GPU Nuclear Corporation

Subject: Three Mile Island Nuclear Station, Unit 1 (TMI-1)
Operating License No. DPR-50
Docket No. 50-289
Inservive Testing of ASME Code Class 1, 2, and 3 Pumps and Valves
(IST) - Response to NRC Questions Regarding Code Relief for the
Third Ten Year Interval

RELIEF REQUEST NO. P 1 (REVISED)

FIGURE 1

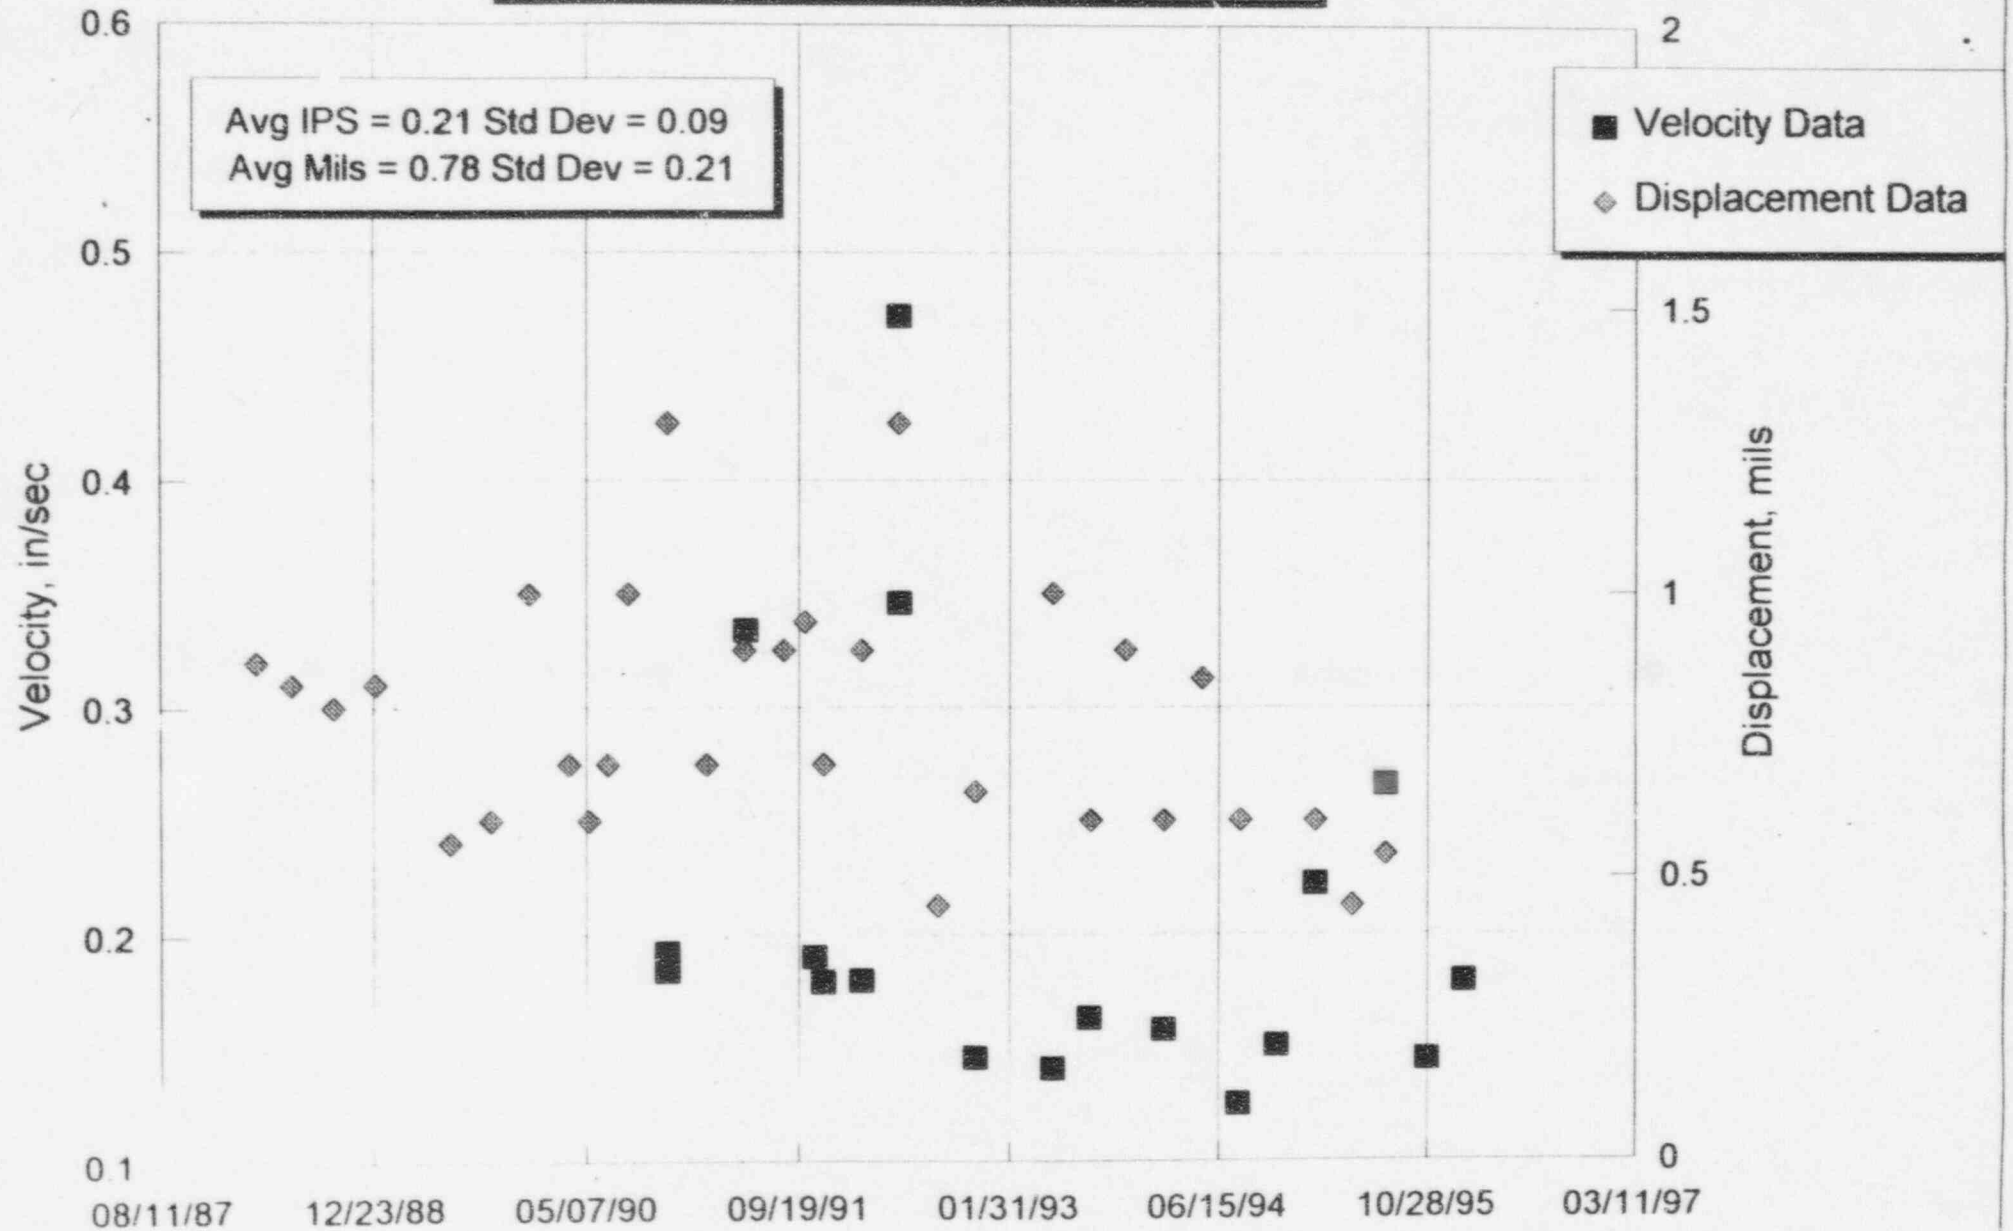
Relief requests to raise the vibration alert range should be done on a pump specific basis. The relief request(s) will be evaluated for each individual pump. Information on pump vibration history (including, pump, specific bearing, vibration direction and dates) can be provided in either raw or graphical form. A discussion of the investigation into the high pump bearing vibration levels, including any discussion with the manufacturer and any actions taken, should be included.

A number of these relief requests have been granted. Typically, the alert range will be increased in the specific direction to a level that exceeds historical vibration levels for that particular pump.

Figures 1 and 2 show vibration data from tests of the DH Pumps (DH-P1A and DH-P1B, respectively) since 1987. Points shown represent the highest vertical overall amplitude since amplitudes in the vertical direction are higher than the horizontal vibration amplitudes. The vibration spectrum is essentially all at vane pass frequency with no 1X or 2X harmonics that could indicate pump problems. These data present a clear case for raising the allowable vibration levels for DH-P1B. Several attempts have been made to reduce the vibration levels for the Decay Heat Pumps, including pump motor alignment, strengthening the backfoot, and adding lead weights to the back end of the pump.

Based on the successful operating history of DH-P1B, no step changes or trends in vibration data as shown on Figure 1, extensive vibration analysis, shop testing, and vendor input, GPU Nuclear does not consider the vibration amplitudes of DH-P1B unacceptable. Replacing or modifying the pumps to reduce vibrations only to assure they do not occasionally exceed 0.325 ips could be unnecessary. Further, doubling the test frequency would result in running the pumps more often at low flow conditions and would provide no useful information. Therefore, this request to allow raising the alert range to greater than 0.400 ips (vs greater than 0.325 ips) is justified for DH-P1B.

GPU Nuclear will limit the request at this time to Decay Heat Pump 1B (DH-P1B). This generic relief request is therefore withdrawn and a new specific relief request No. P 4 has been added for raising the vibration alert range for DH-P1B from 0.325 ips to 0.400 ips in the vertical direction. See New Relief Request No. P 4.
